Date September 12, 2019
To Town of Cumberland Planning Board
From Carla Nixon, Town Planner
Subject **Final Plan Review: 20 Lot Major Subdivision –Christmas Creek**

The Applicant is Beta Zeta Properties. The Applicant is requesting Final Plan Review of a proposed 20 lot major subdivision. The lots will be served by public water and sewer and natural gas. The 50.58 acre parcel is located off Tuttle Road in the Rural Residential 1 zoning district as shown on Tax Assessor Map R4, Lot 10. Thomas Perkins, P.E., of Dirigo Architectural Engineering is the Applicant's representative.

ENLARGED ENTRANCE PLAN
22X34 SCALE: 1"=10'
11X17 SCALE: 1"=20'

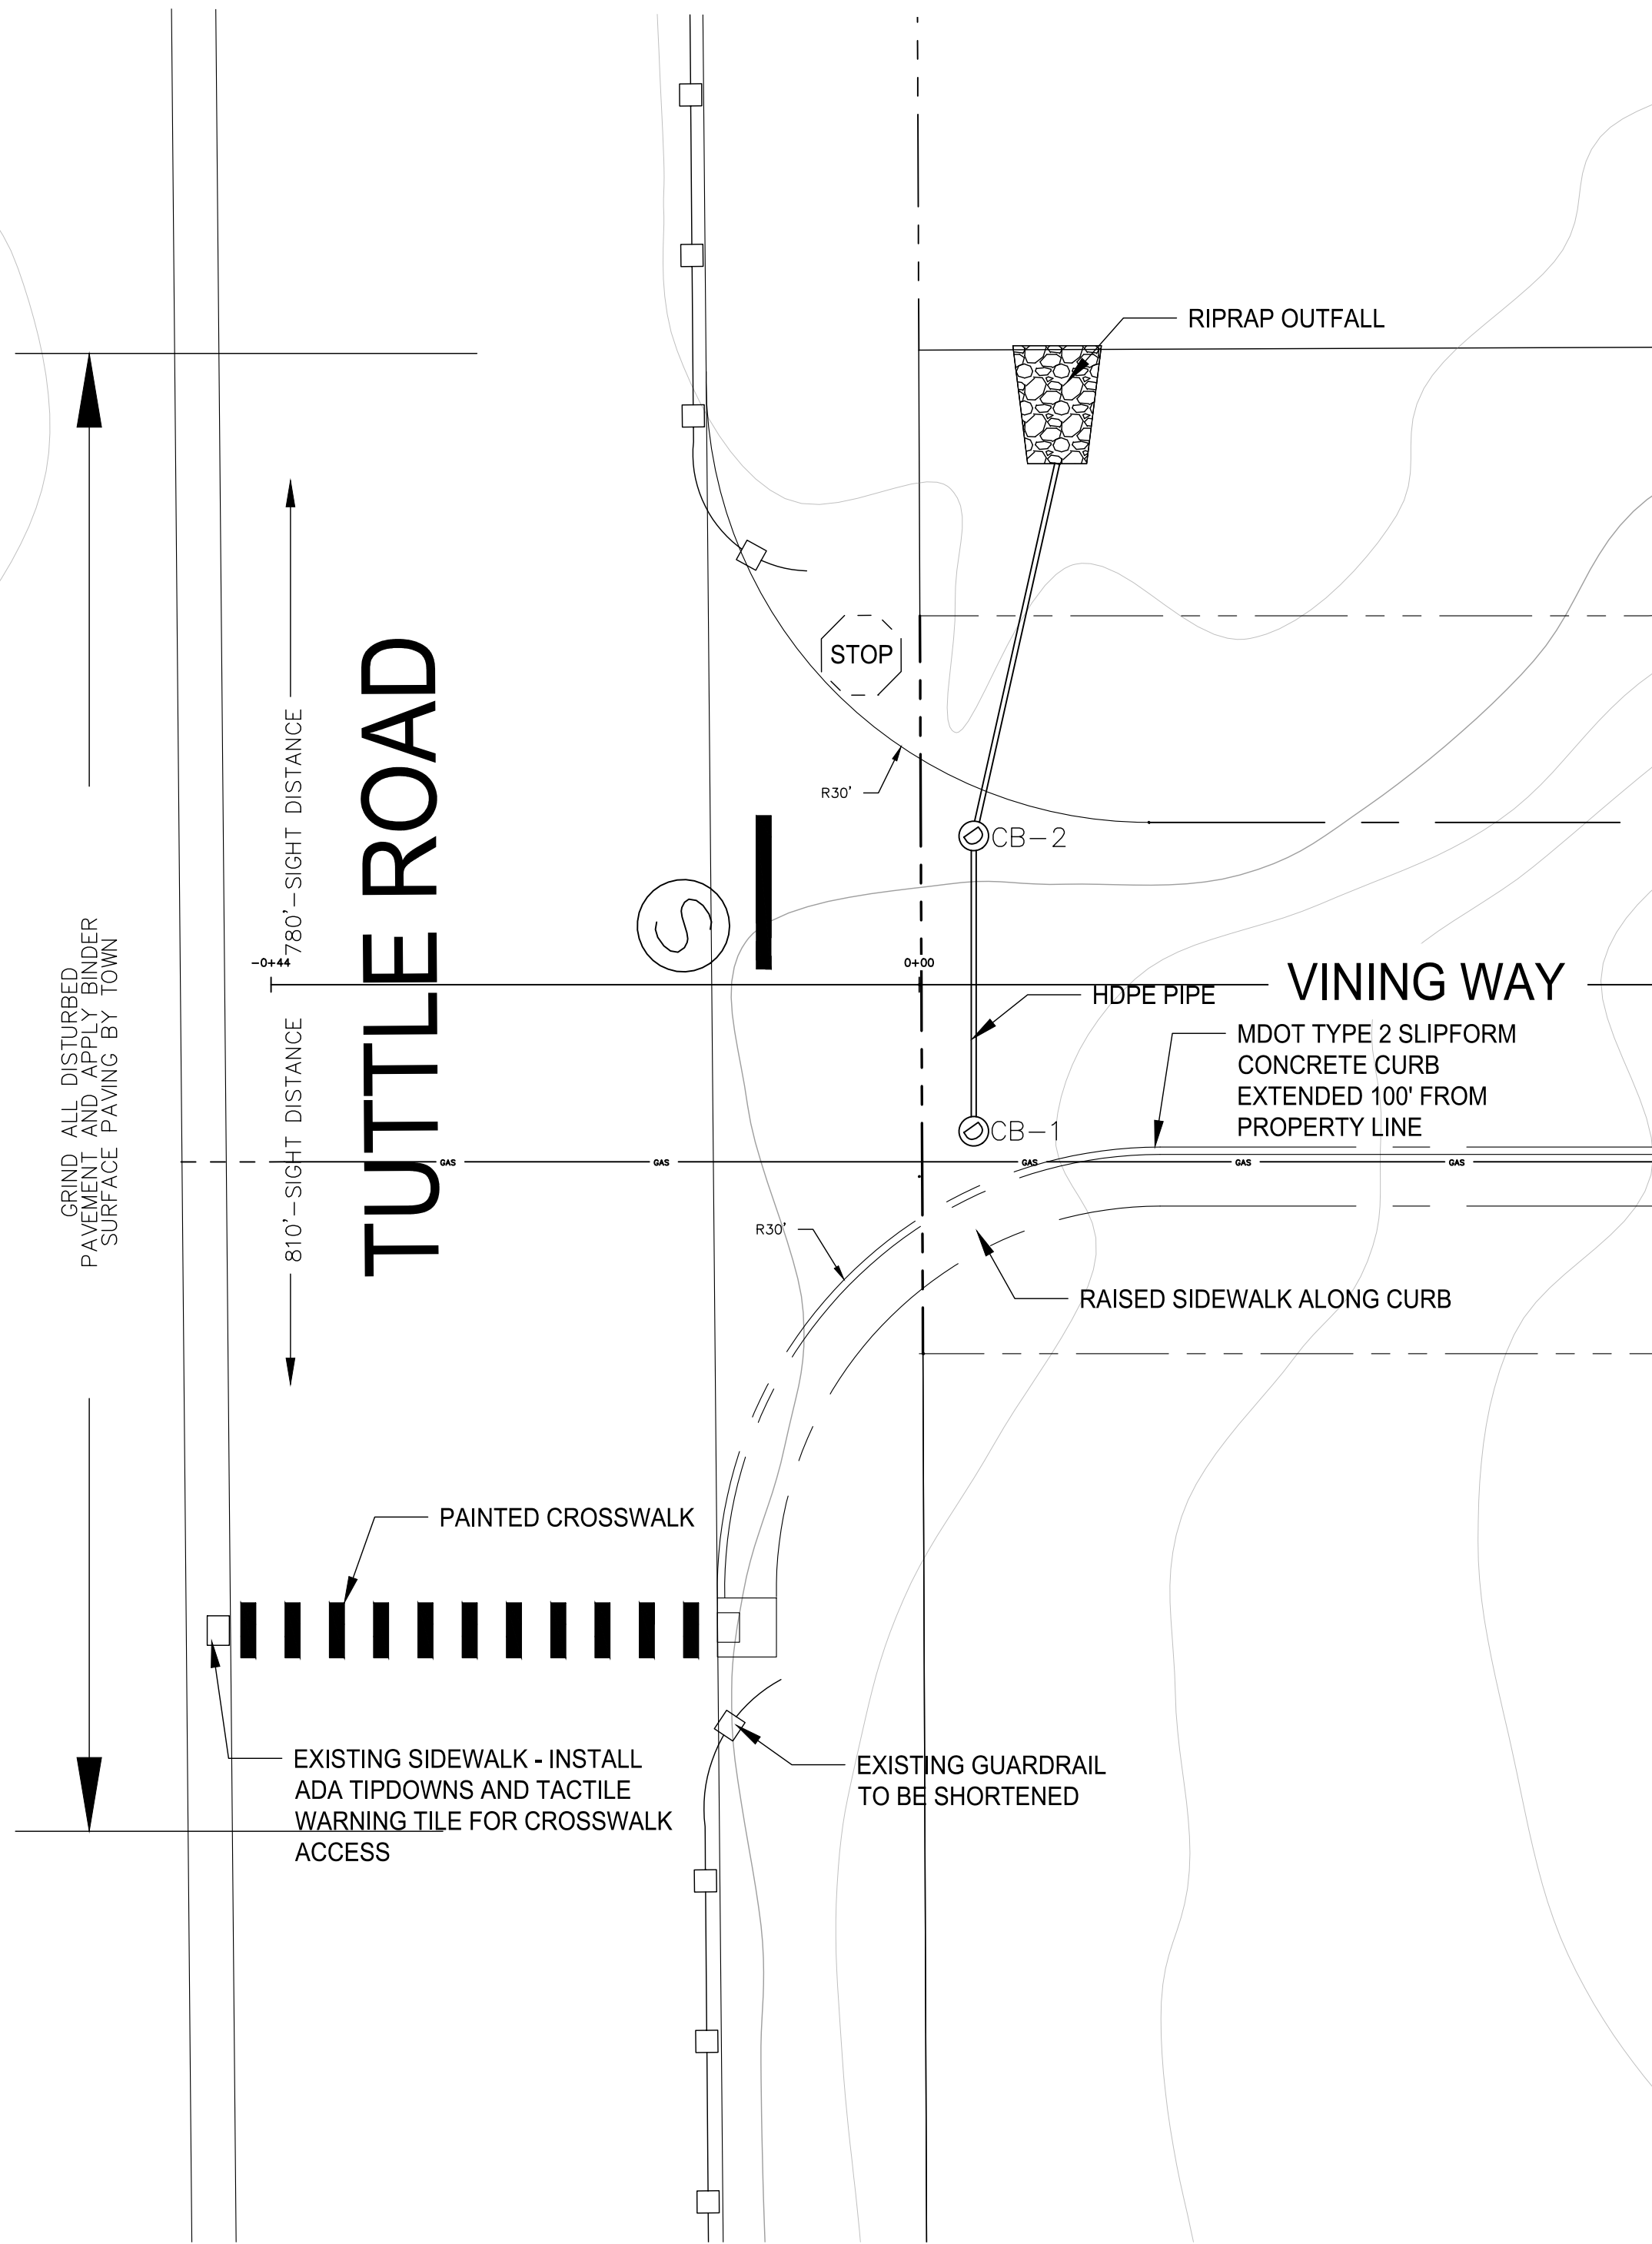
S - The entrance shall be constructed in general conformity with a drawing titled "Enlarged Entrance Plan", sheet no. C2.1, drawn by Dirigo Architectural, revision 3, dated 4/30/2019.
